PENTON RESIDENCE
23160 LOWE DAVIS RD
RENOVATION/ADDITION PLANS
COVINGTON, LA.

REVISION DATES:		
No.	DATE	PURPOSE
1	5-24-22	REVIEW COMMENTS ADDRESS

FLOOR FRAMING PLAN
SCALE: 3/16"=1'-0"

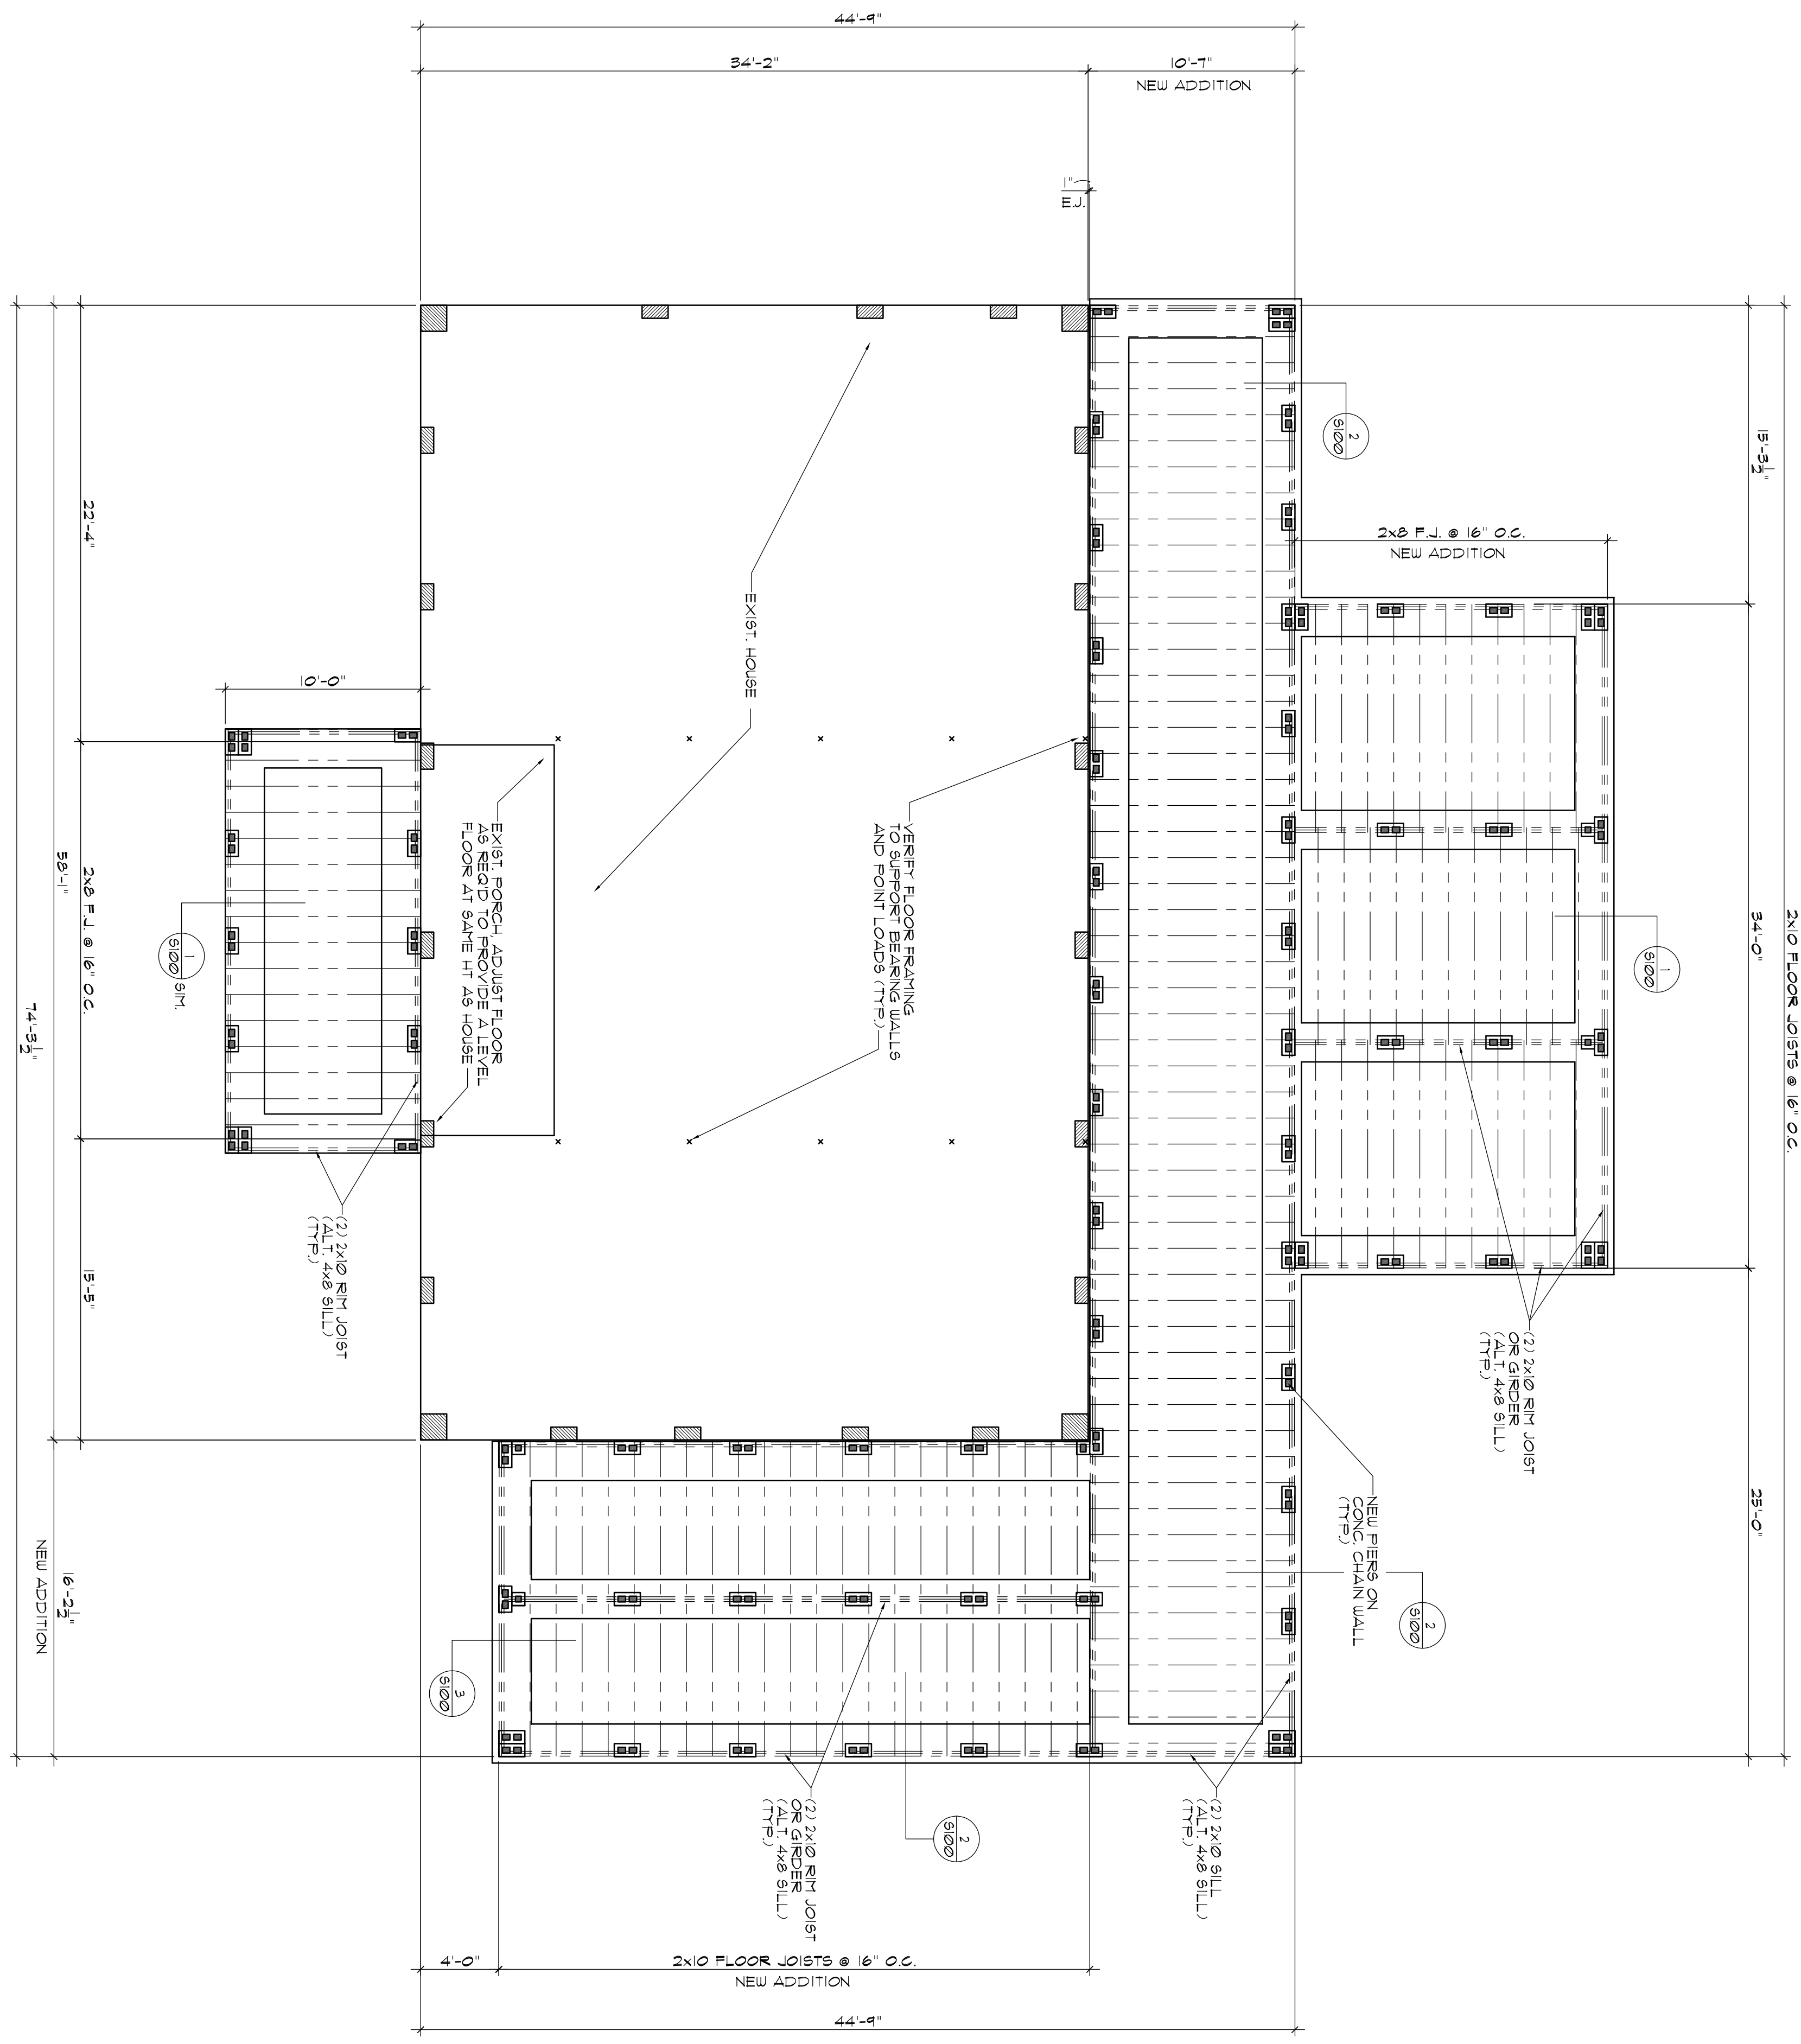
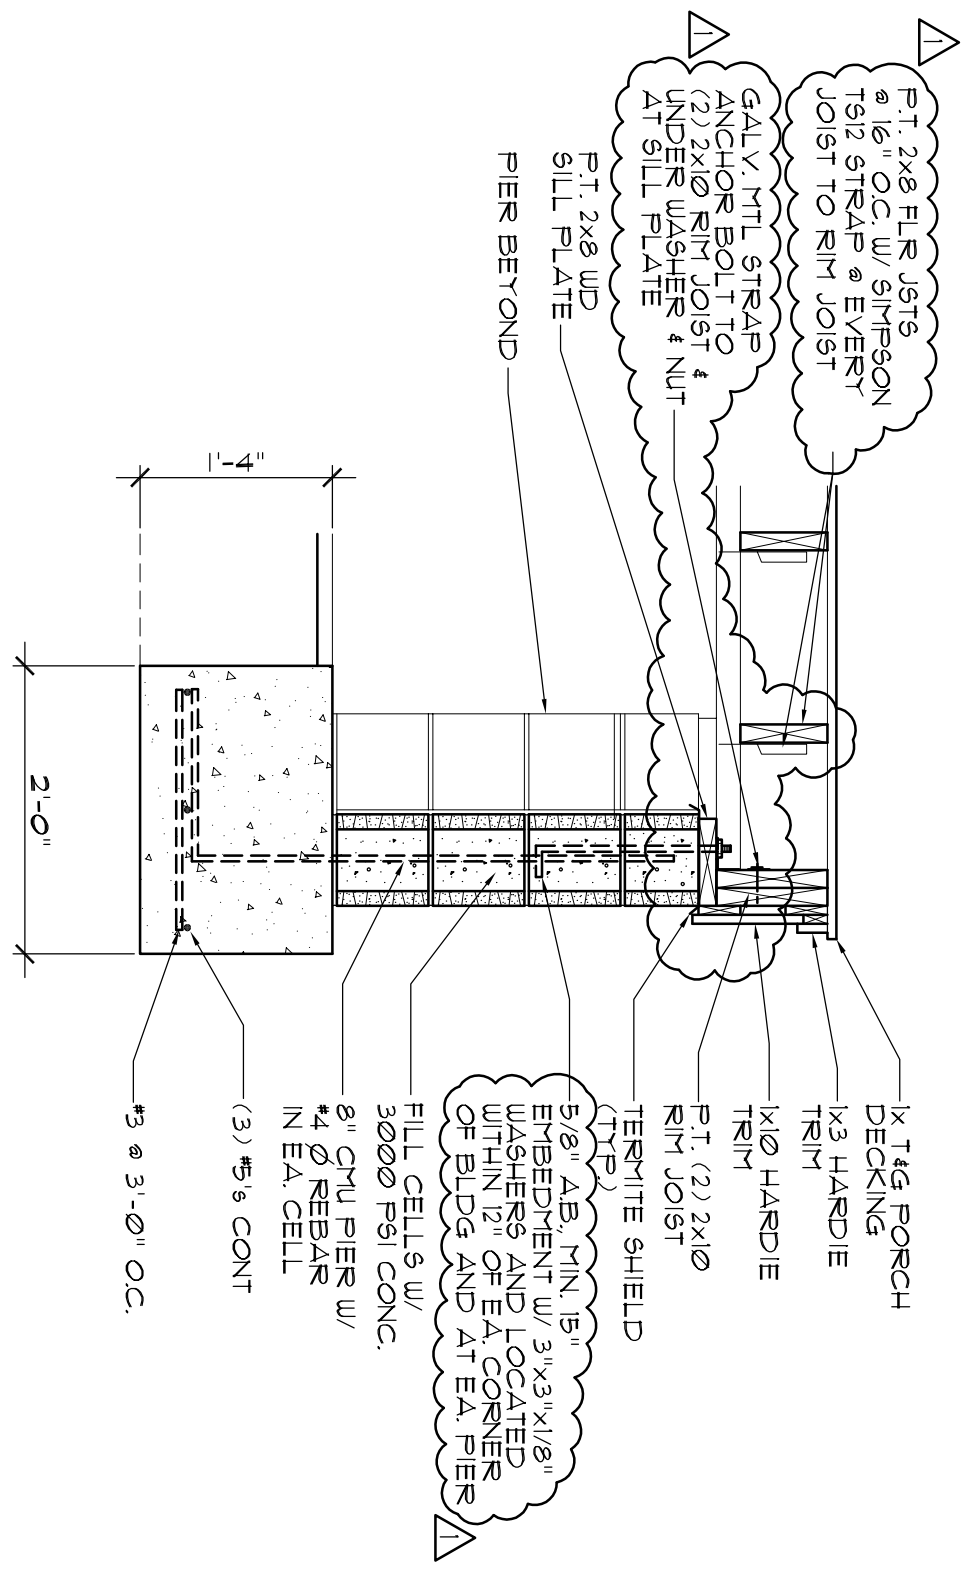
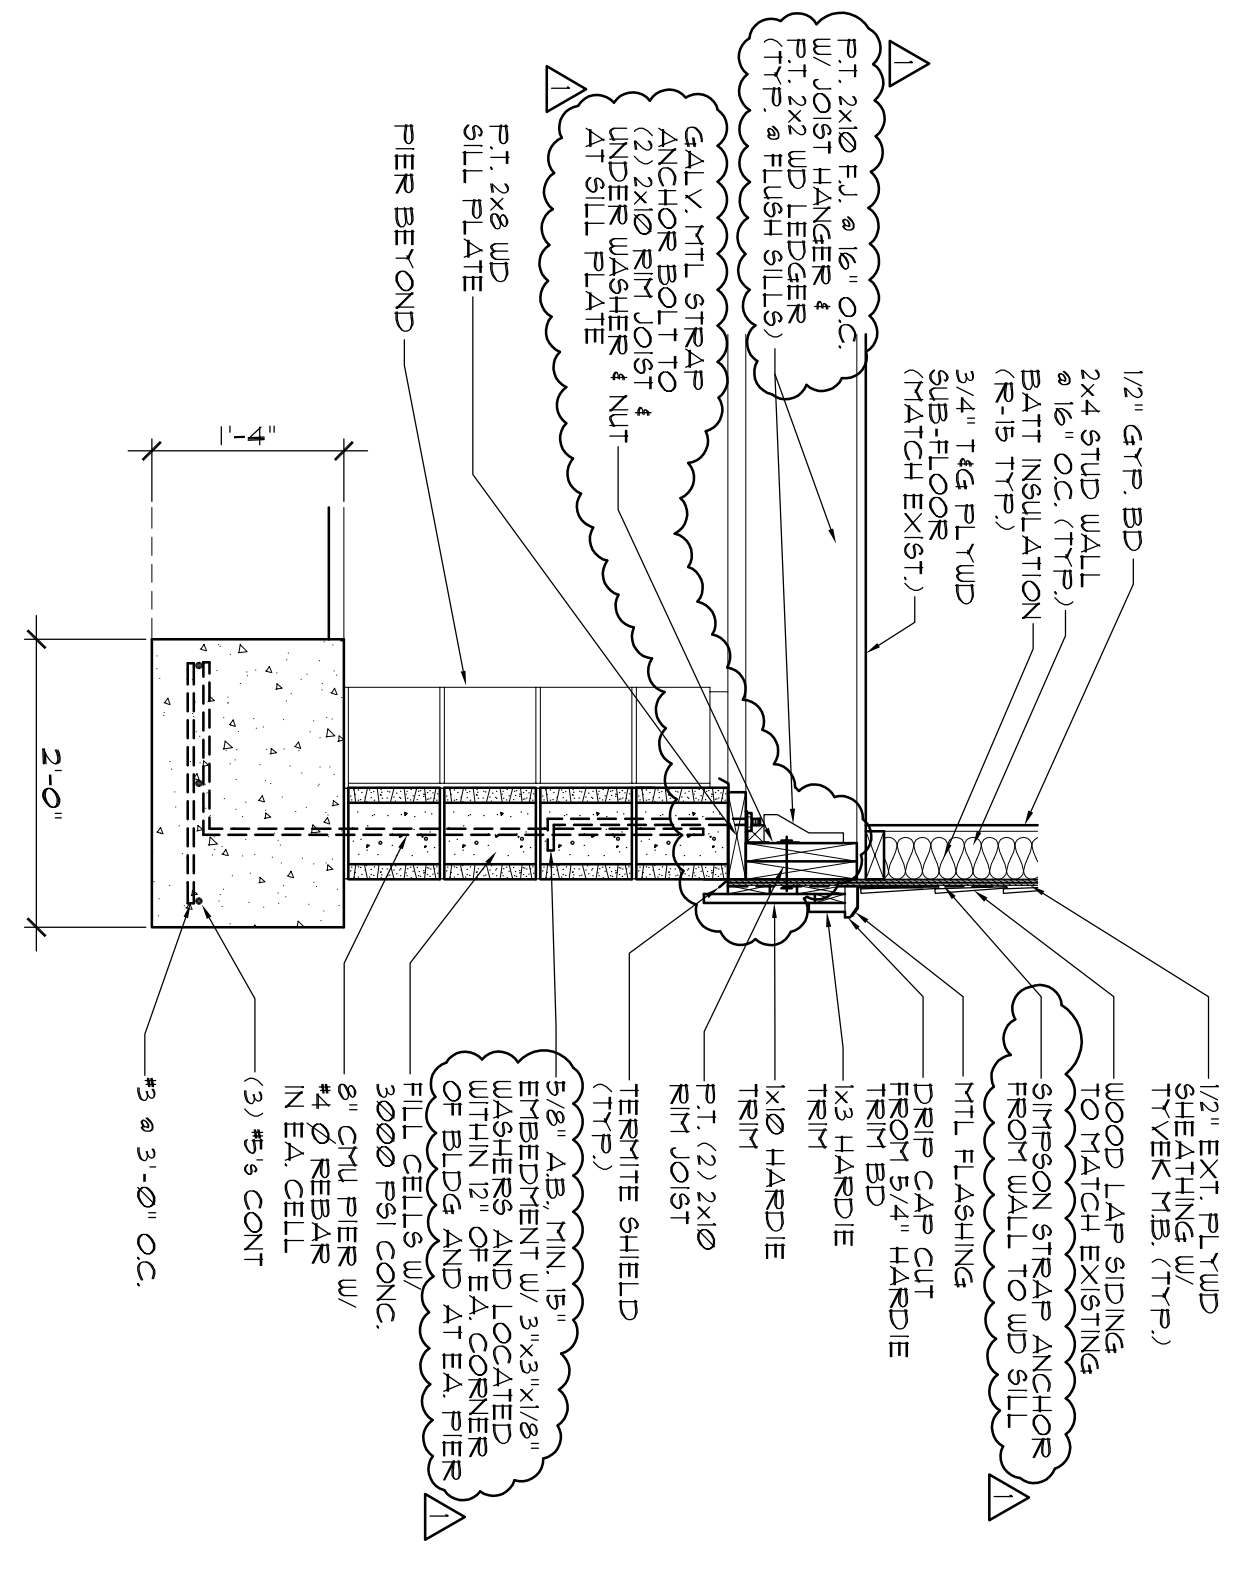
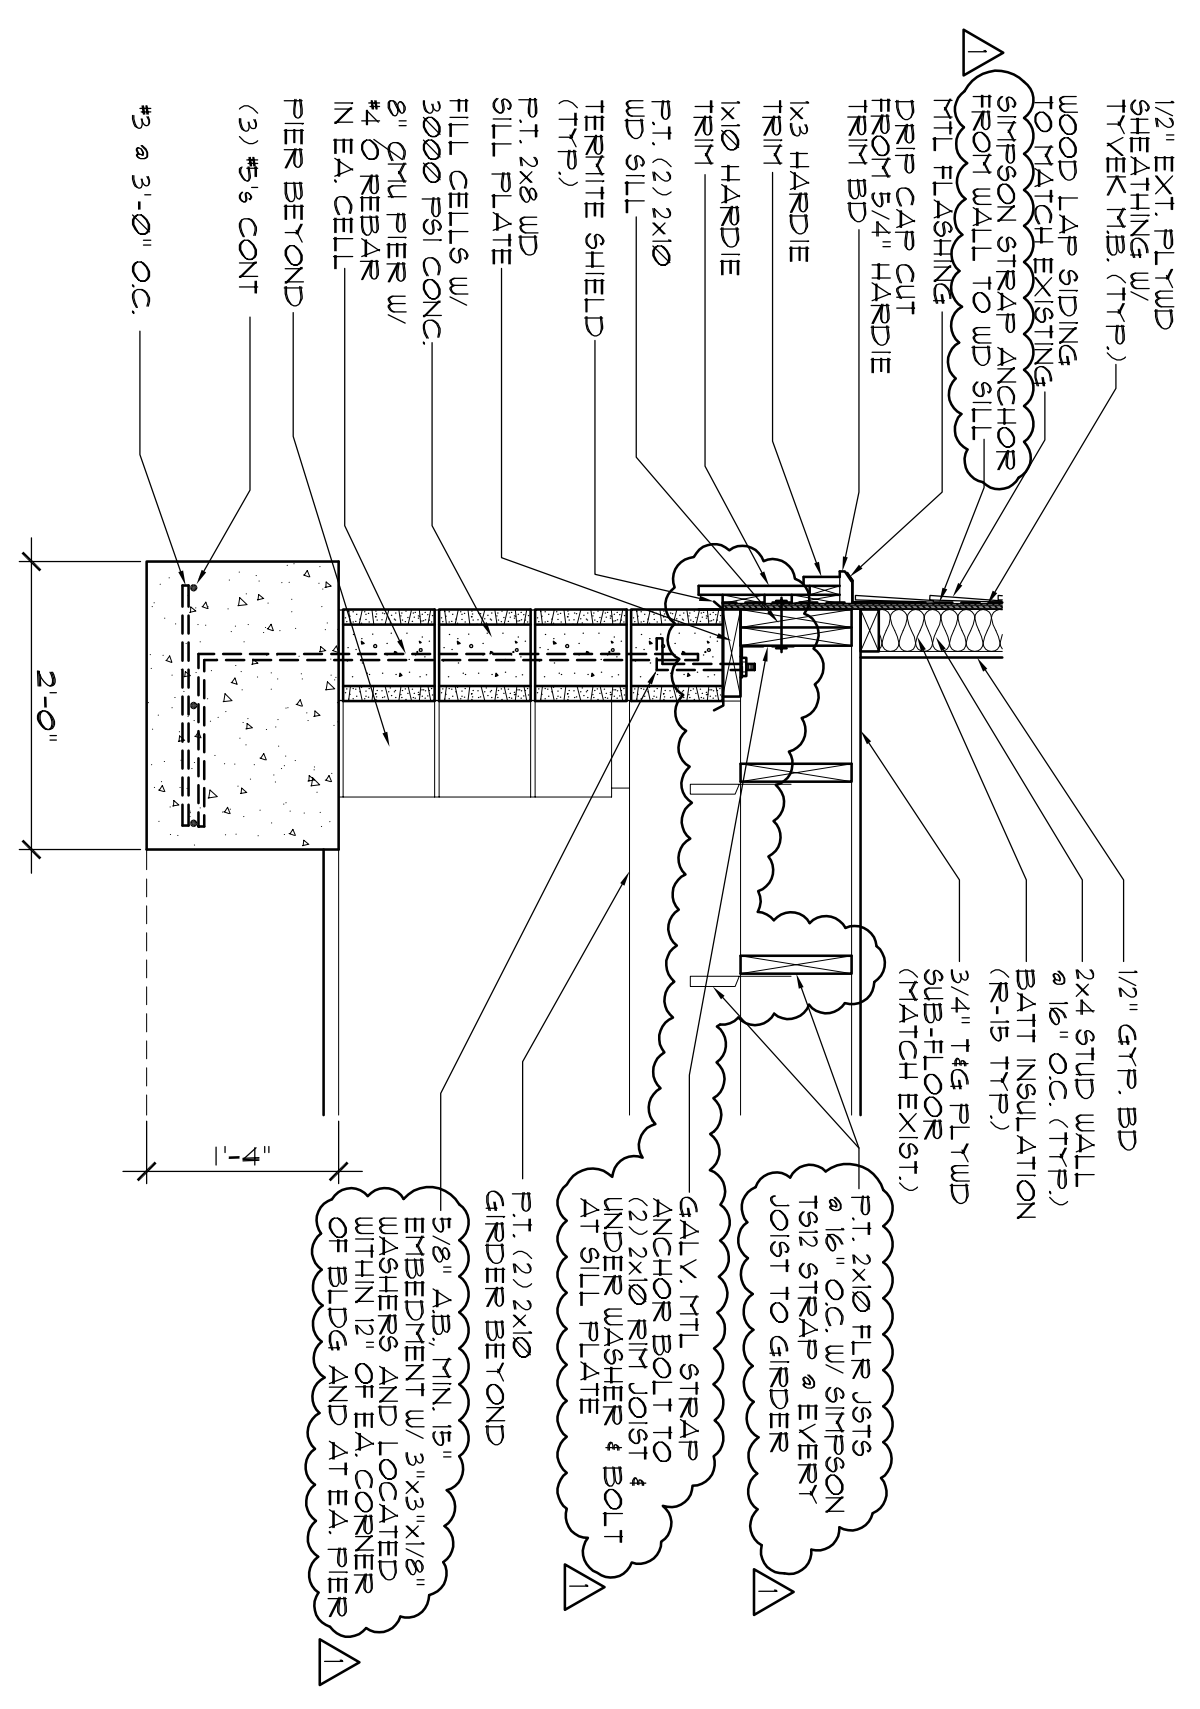
CMU ANCHOR BOLTS ADDED.
WALL STRAP ANCHOR ADDED.
JOIST HANGERS & WD LEDGER ADDED.
